# EVS-GTR vibration load proposal

EVS-GTR 16th

China

## EVS-GTR No.20 /ECE R100

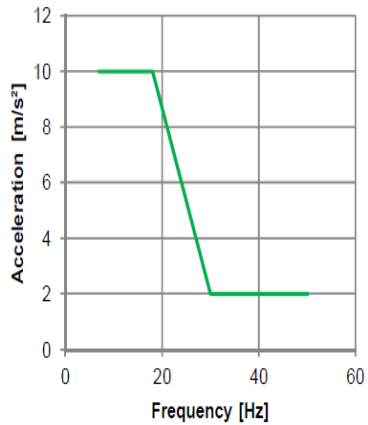
To sum up, for saving test resources, in order to be covered by UN38.3, current profile is not from real vehicle measurement data, while it is derived from UN38.3, a transportation regulation. UN38.3 is to simulate transportation working load, not for normal operation. So it is **totally conflicted with the original purpose.** **So this logic should be changed**

➤ **Random vibration profile is more reasonable than sinus sweep vibration profile for EVS GTR No.20**

- **EVS GTR vibration profile's purpose is to simulate vehicle normal operation;**
- **EVS GTR vibration profile should be created from real measurement data, instead of being derived from UN38.3;**
- **Two versions of vibration profile (new GB and ISO6469-1) are both coming from real measurement data;**
- **New GB and ISO 6469-1 mainly have the same logic and methodology;**
- **China propose new GB as a proposal for next EVS GTR vibration profile;**
